# Regional Review Finding

## Development of Regional Impact

**RE:** Development of Regional Impact (DRI) Review

**Name of Proposal:** Le Jardin Subdivision DRI 4348

**GRTA DRI SITE PLAN - A**

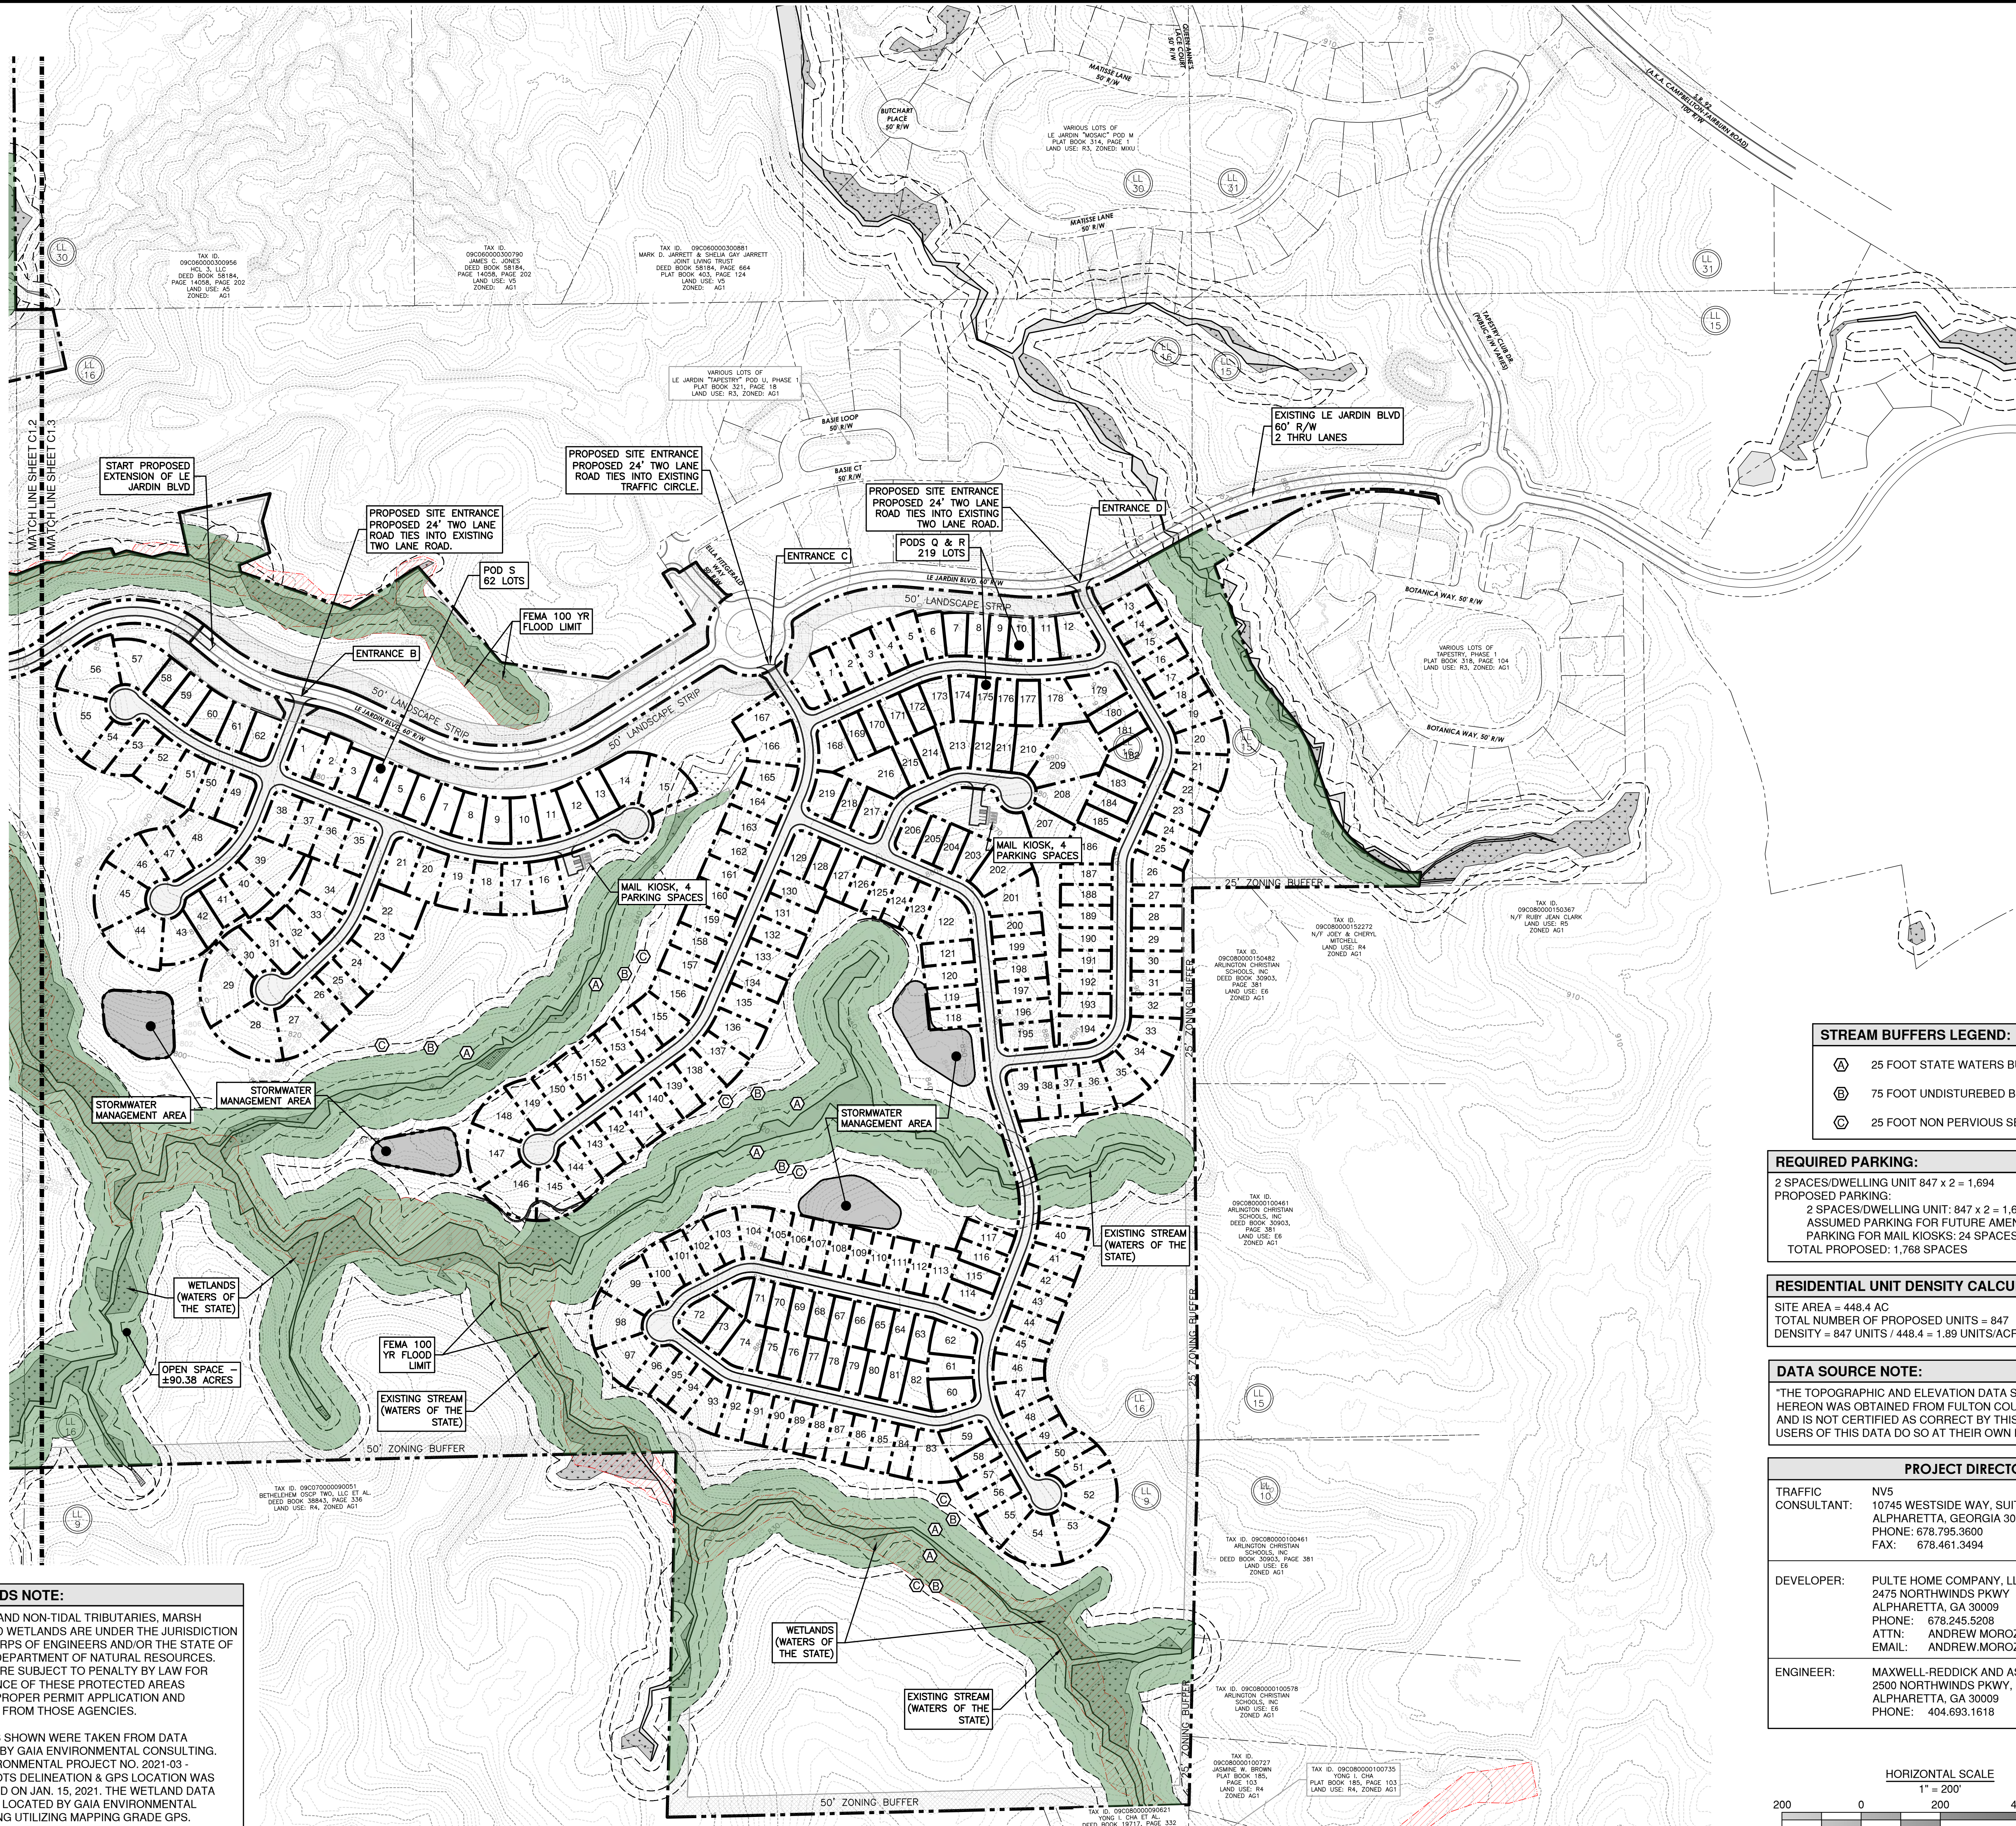
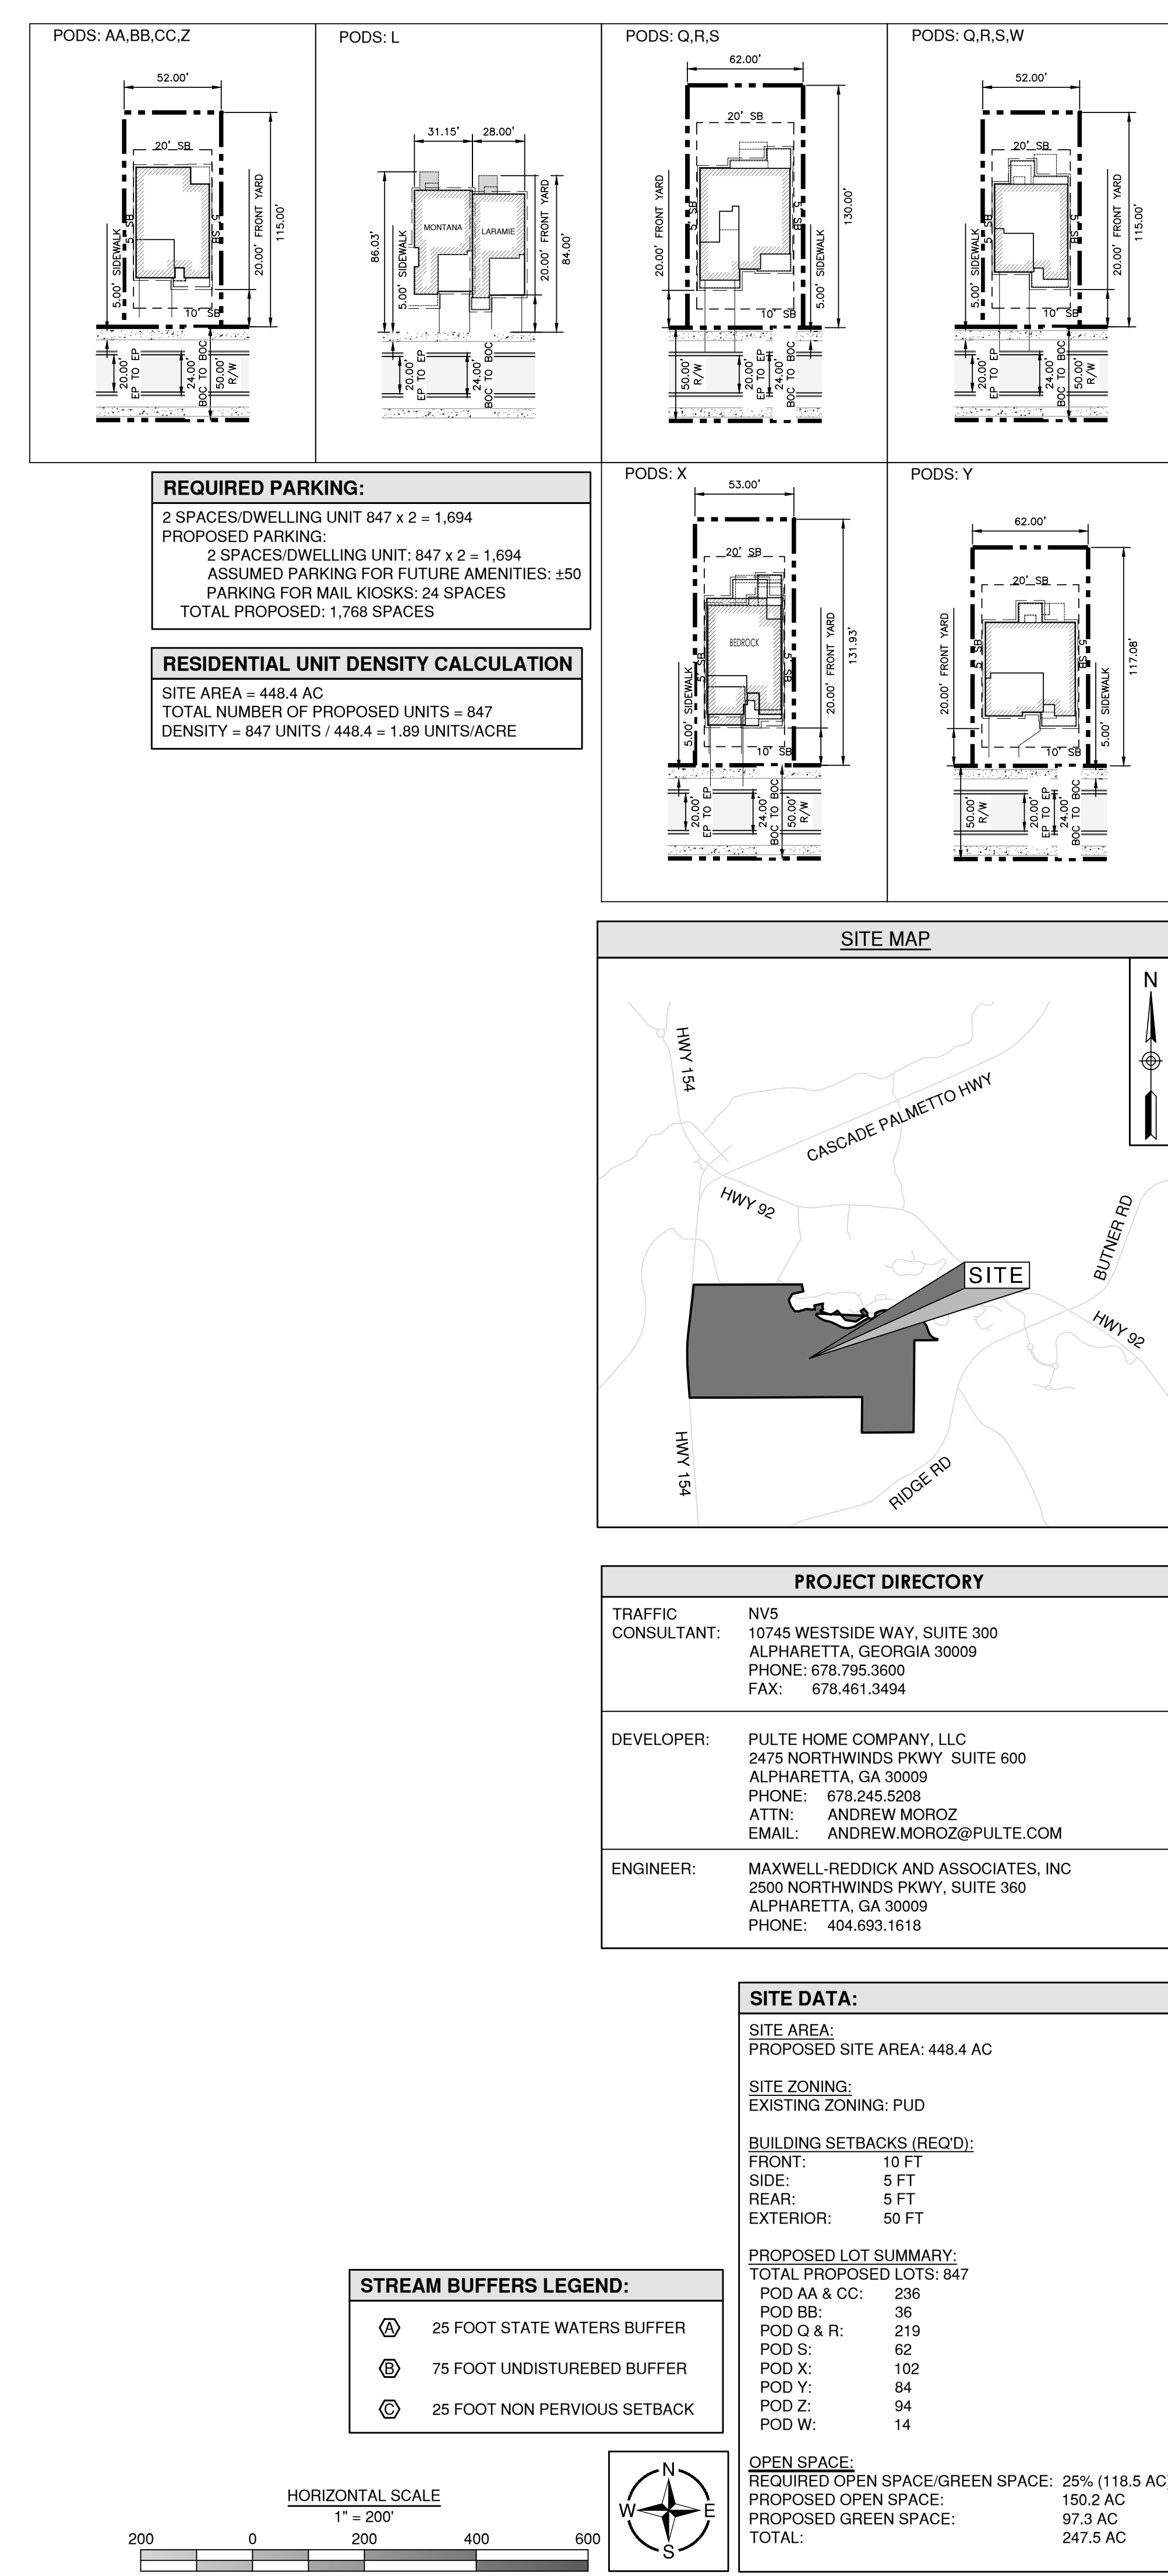
*The project generally avoids stream buffer intrusions which is supportive of regional water supply and environmental policies. Some of the single-family lots do extend in to buffer areas and the city should ensure that the permitting process for the construction of homes on these lots excludes actual construction in these areas.*

The submitted site plan and USGS coverage for the project area shows Town Creek crossing the property from the southeast corner of the property to the northwest. The USGS coverage also shows three unnamed tributaries to Town Creek. The submitted site plan shows these streams as well as several other unnamed tributaries. The 100-foot impervious setback and 75-foot undisturbed buffer required under the City of South Fulton's Unified Stream Buffer Protection ordinance, as well as the State 25-foot Erosion and Sedimentation Buffer are shown on all streams and are identified in a legend box on the site plan. The only intrusions shown on the submitted site plan are five transportation stream crossings, which are allowed under the City ordinance. However, portions of several residential lots intrude on the City 100-foot impervious setback and several stormwater management areas and a mailbox kiosk area, are shown nearly abutting the edge of the 100-foot impervious setback. Any intrusions into City buffers or setbacks may require a variance from the City.

The submitted site plans show the FEMA 100 -year floodplain areas the streams on the property. Road crossings are the only intrusions shown in the 100-year floodplain on the submitted plans.
